**METROPOLITAN DEVELOPMENT COMMISSION
HEARING EXAMINER**

Case Number: 2025-CZN-806 / 2025-CPL-806
Property Address: 5433 Shelbyville Road
Location: Franklin Township, Council District #24
Petitioner: Sarabjit Singh and Baljit Kaur, by Pat Rooney
Current Zoning: D-A (FW)
Request: Rezoning 9.109 acres from the D-A (FW) district to the D-1 (FW) district to provide for residential uses.
Current Land Use: Single-family dwelling and accessory buildings.
Staff Recommendations: Approval of the rezoning request, subject to the commitments noted below:
Approval of the plat request, subject to the conditions noted below:
Staff Reviewer: Kathleen Blackham, Senior Planner

Stream Protection Corridor

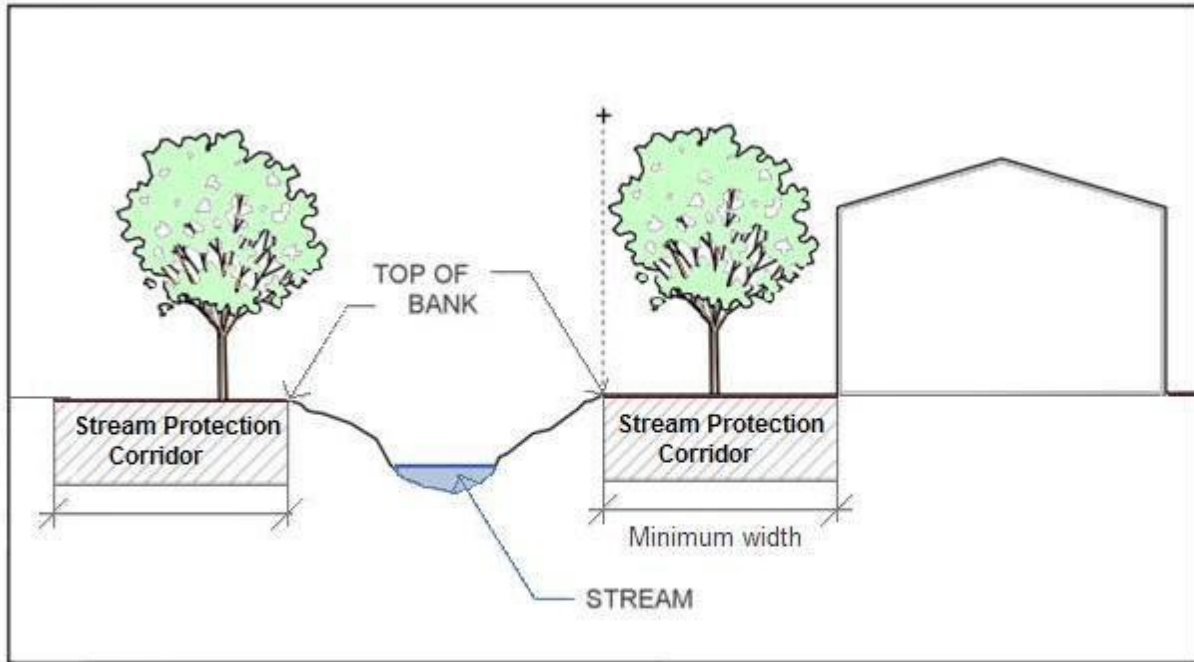
Harting Ditch lies within the Metro Context Area and is located at the northeast corner of the site. It is designated as a Category One stream requiring a 50-foot-wide stream protection corridor on both sides of the stream, as measured parallel from the top of the bank. Top of the bank is not defined by the Ordinance, other than by Diagram UU, Stream Protection Corridor Cross-section, as shown below.

JOB NO. 24-337
 SHEET 1 OF 2

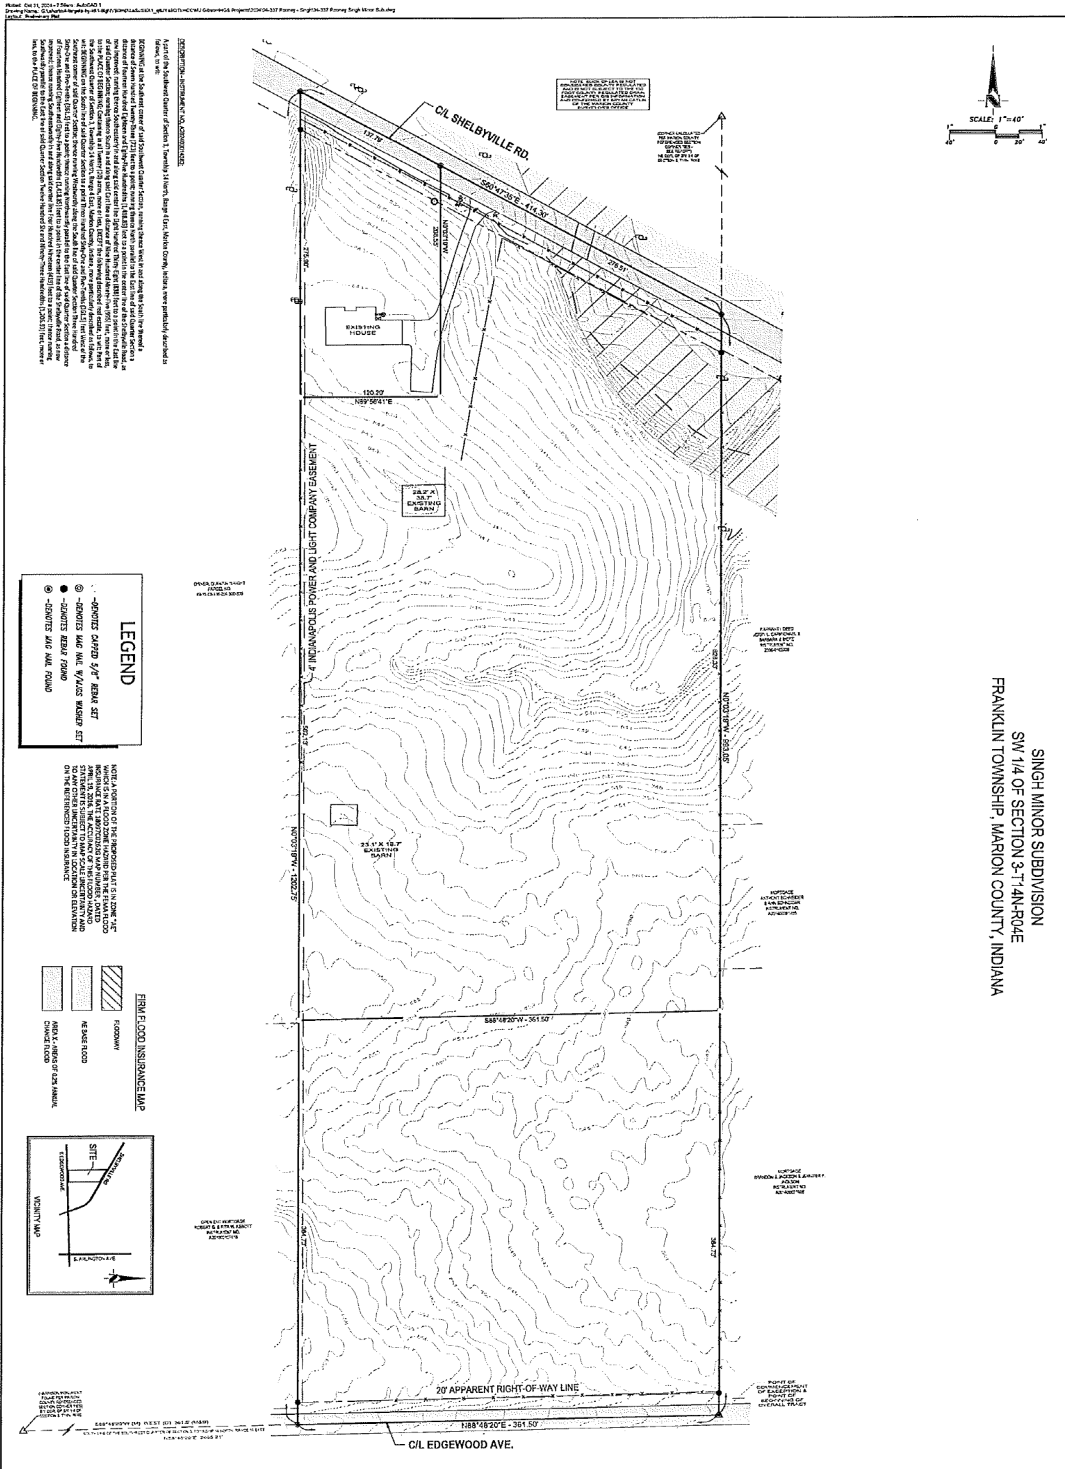
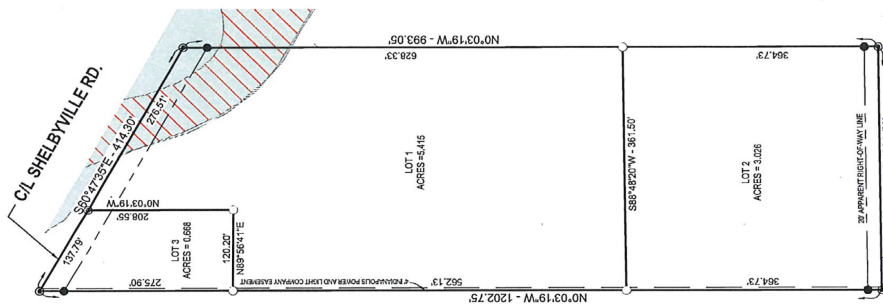
Staff recommends that the Hearing Examiner approve and find that the plat, file dated December 2, 2024, complies with the standards of the Subdivision regulations, subject to the following conditions:

The request would provide for a subdivision plat known as Singh Minor Subdivision that would divide the parcel into three lots. Presumably each lot would be developed with a single-family dwelling. It should be noted that a single-family dwelling exists on the proposed Lot 3 located at the northwest corner of the site.

All three lots front on public streets (Shelbyville Road and East Edgewood Avenue). Therefore, no new streets would be necessary.

Sidewalks do not exist but would be required as development occurs. A Performance Bond would also be required during the platting process.

1. That the applicant provides a bond as required by Section 741-210, of the Consolidated Zoning and Subdivision Ordinance.
2. Subject to the Standards and Specifications of Citizens Energy Group, Sanitation Section.

3. Subject to the Standards and Specifications of the Department of Public Works, Drainage Section.
4. Subject to the Standards and Specifications of the Department of Public Works, Transportation Section.

5. That addresses and street names, as approved by the Department of Metropolitan Development, be affixed to the final plat prior to recording.
6. That the Enforcement Covenant (Section 741-701, of the Consolidated Zoning and Subdivision Ordinance) be affixed to the final plat prior to recording.
